Addendum No. 4

PROJECT NO. 161026-00

PROJECT TITLE: Renovate Plant Science Building - Phase 2

DATE: **November 17, 2026**

STRUCTURAL-FIRST FLOOR PLAN - PHASE 2

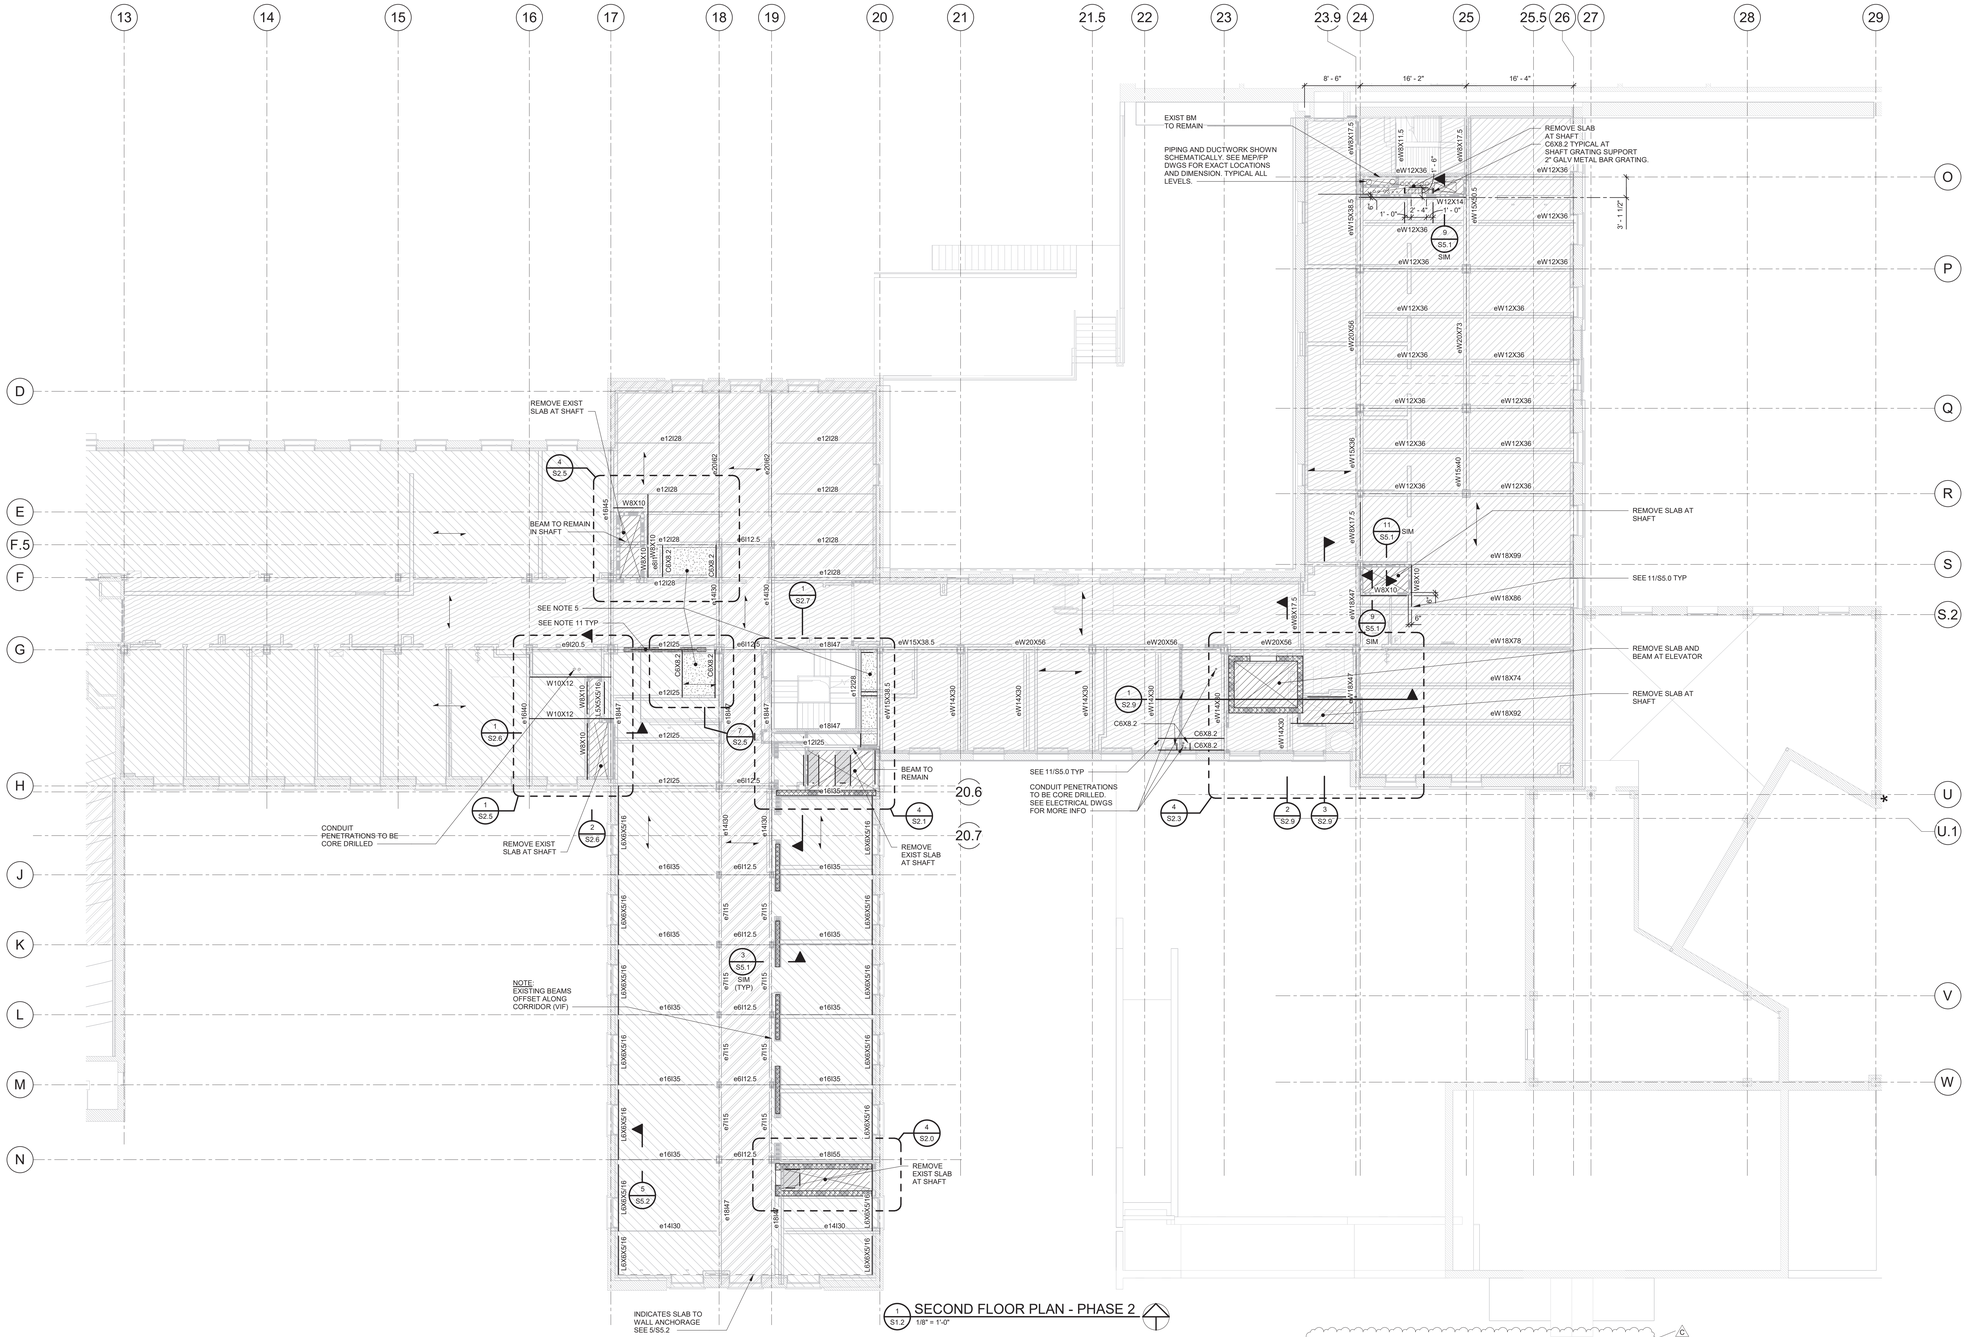
4.2a: S1.1, S1.2, S1.3, S1.4, S1.5 – ADDED text to general note: ASSUME 75 SF OF CONCRETE ENCASEMENT PATCHING AT THIS LEVEL FOR ESTIMATING PURPOSES ONLY. CONTRACTOR TO VERIFY IN FIELD.

7 S5.3 ELEVATION
1/4" = 1'-0"

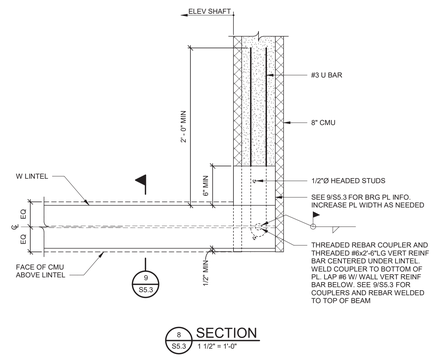
4.2d: S5.3 – ADDED a note to view 7 indicating: SEE ARCH DWGS FOR PAINT REQUIREMENTS AT HSS ROOF DUCT FRAMES, TYPICAL

DOOR & FRAME SCHEDULE - PHASE 2

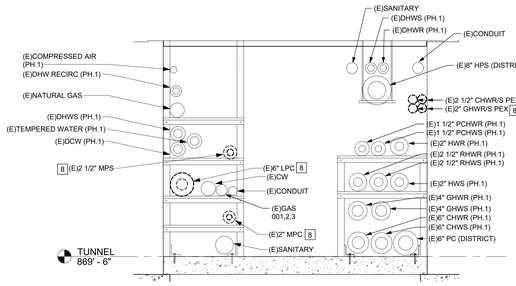
4.2n: A9.11 – REVISED door schedule elements throughout where clouded. ADDED general notes and glazing schedule..

1 MECHANICAL TUNNEL PIPING DEMOLITION PLAN - PHASE 2
1/8" = 1'-0"

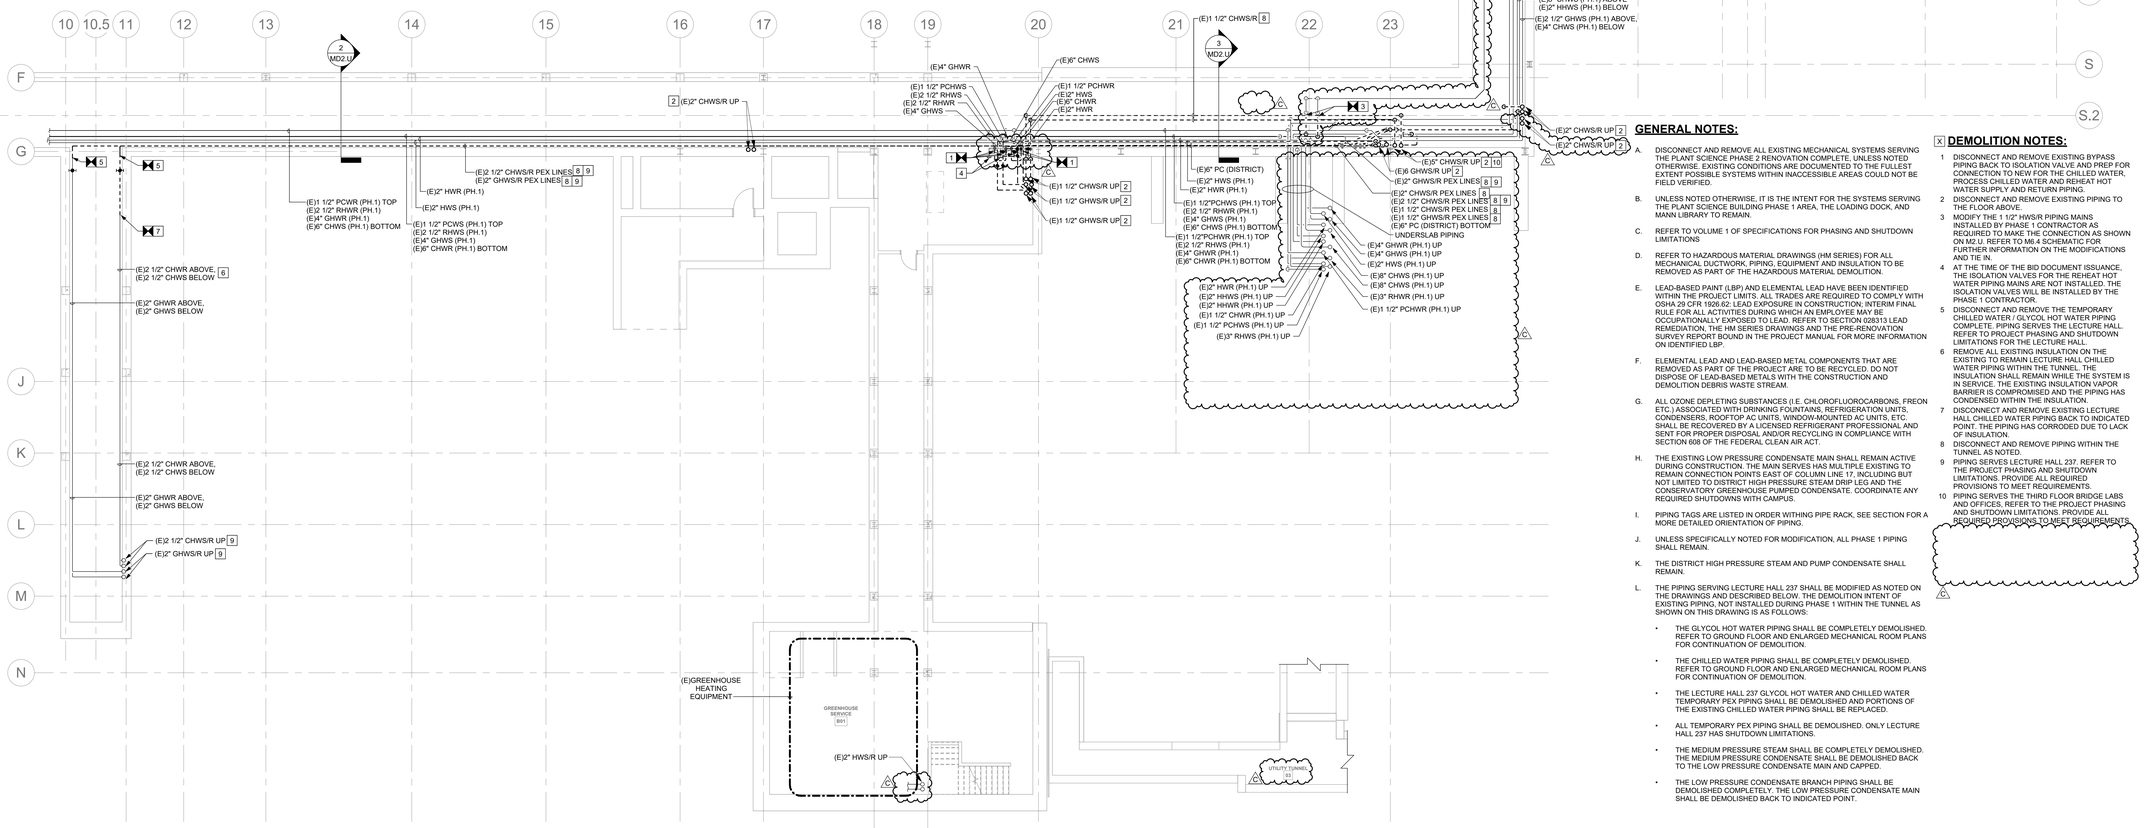
4.2q: MD2.U – REVISED existing isolation valves for 6” CHWS/R and 4” GHWS/R from ball valve to butterfly valves. ADDED Utility Tunnel 03 Room Tag. ADDED (E)2” HWS/R piping within the greenhouse heating equipment callout. REVISED piping configuration and tagging for (E)2" GHWS/R. ADDED (E)1 1/2" HWS/R (PH.1) piping within Mechanical B00UG. REVISED Demolition Note 3. DELETED Demolition Note 11. REVISED existing PH.1 GHWS/R, CHWS/R, RHWS/R, PCHWS/R, HHWS/R, and HWS/R under slab piping and piping riser’s configuration to match existing conditions.

MECHANICAL FOURTH FLOOR PRESSURIZATION & CONTROLS PLAN - PHASE 2

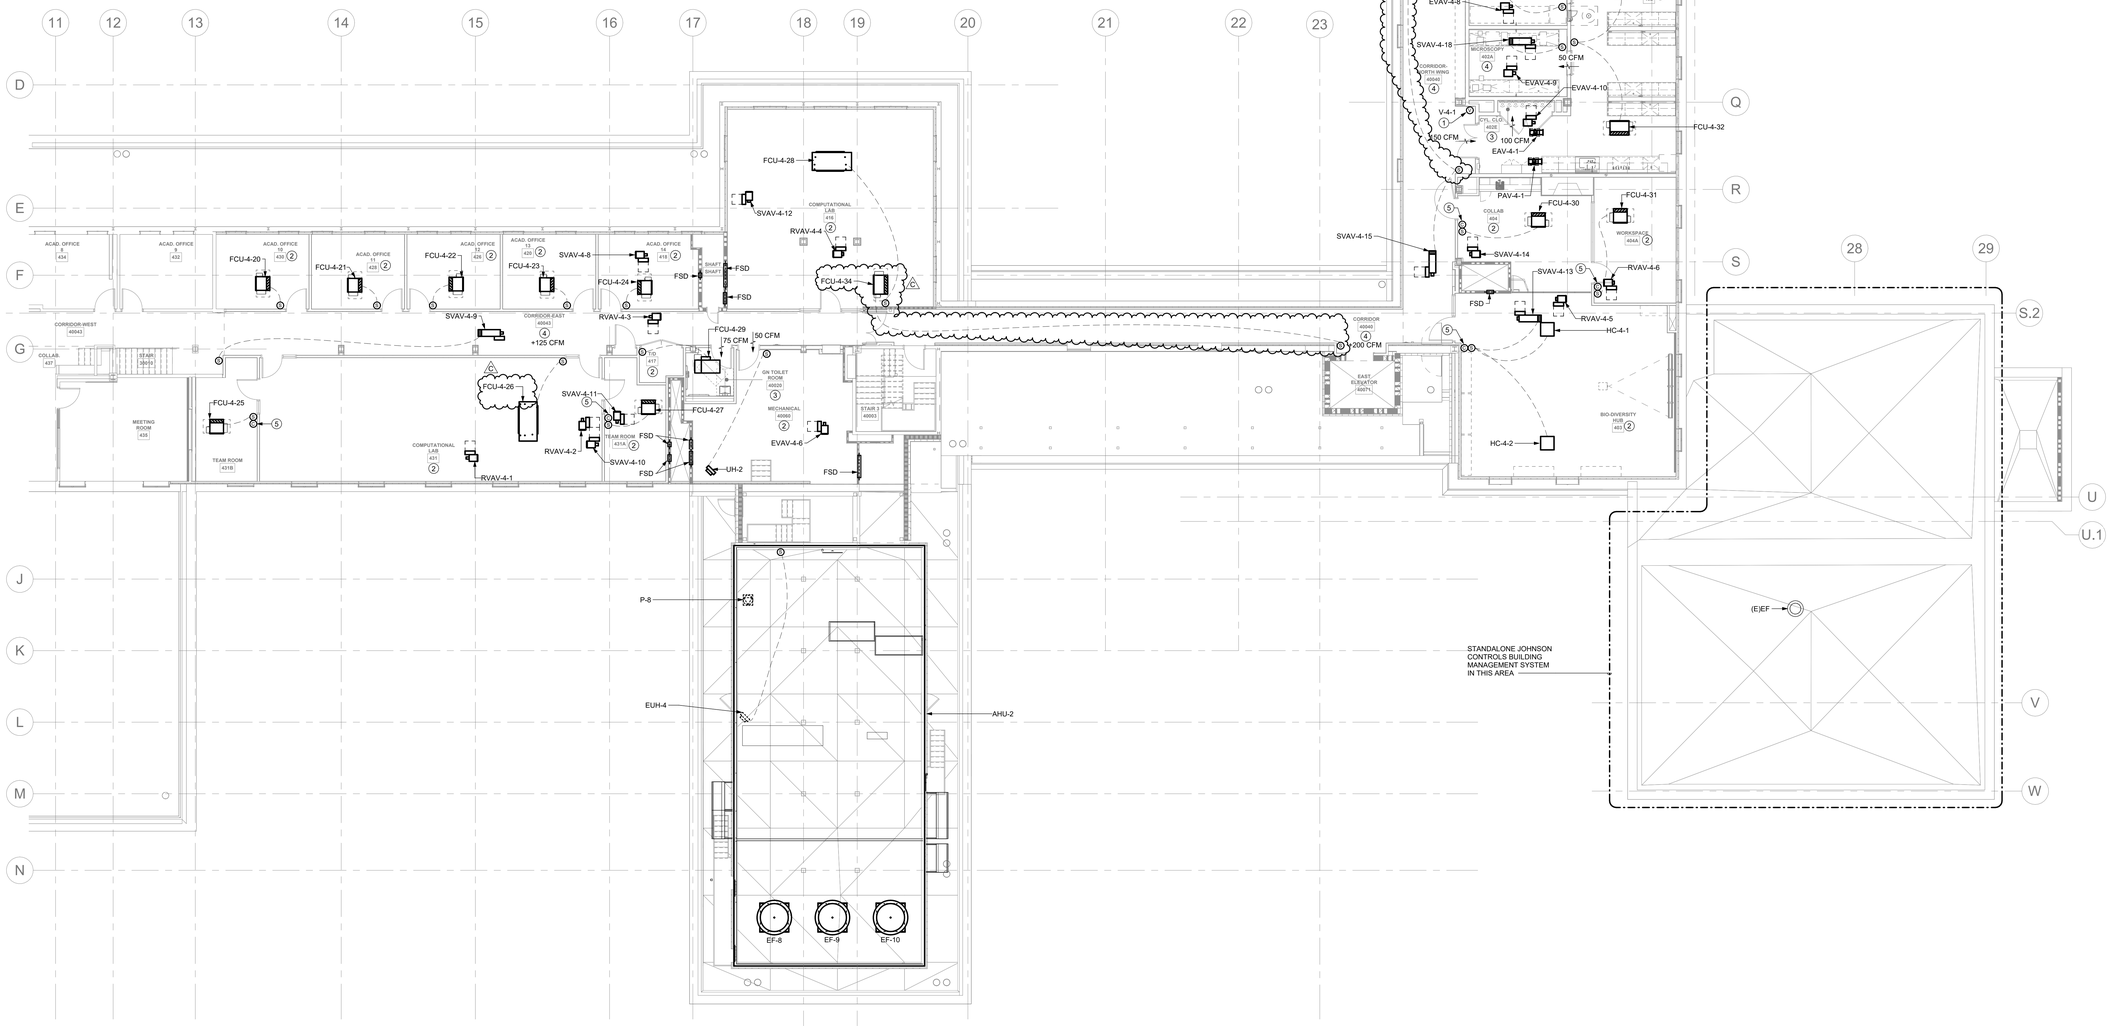
4.2w: M3.4 – ADDED tag for FCU-4-26 in Computation Lab 431. ADDED AAD tag in Detail 7. REVISED control wiring to FCU-4-34 and FCU-4-33. REPLACED vertical exposed FCU-4-33 and FCU-4-34 from Corridor 40040, with horizontal concealed unit. REVISED locations of FCU-4-33 and FCU-4-34

4 POINT OF USE EXHAUST TERMINATED THROUGH CEILING DETAIL
NTS

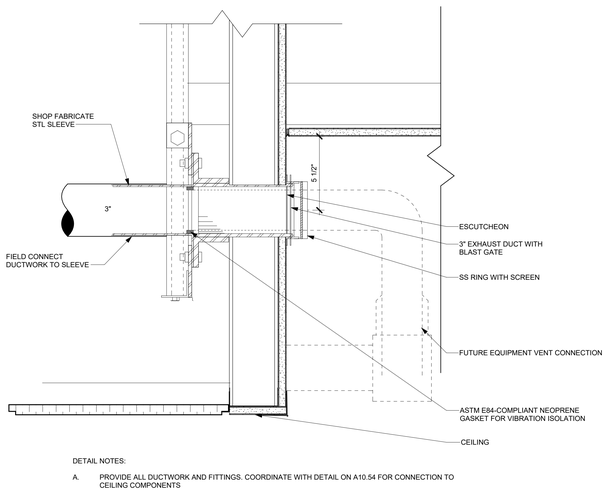
4.2y: M7.4 – ADDED Detail 4 Point of Use Exhaust Terminated Through Ceiling Detail. ADDED Detail 5 Point of Use Exhaust Terminated Through Soffit Detail. ADDED Detail 6 Flammable Cabinet Detail. ADDED Detail 7 Vacuum Pump Cabinet Venting Detail. ADDED Detail 8 Lab 118 Process Exhaust Venting Detail.
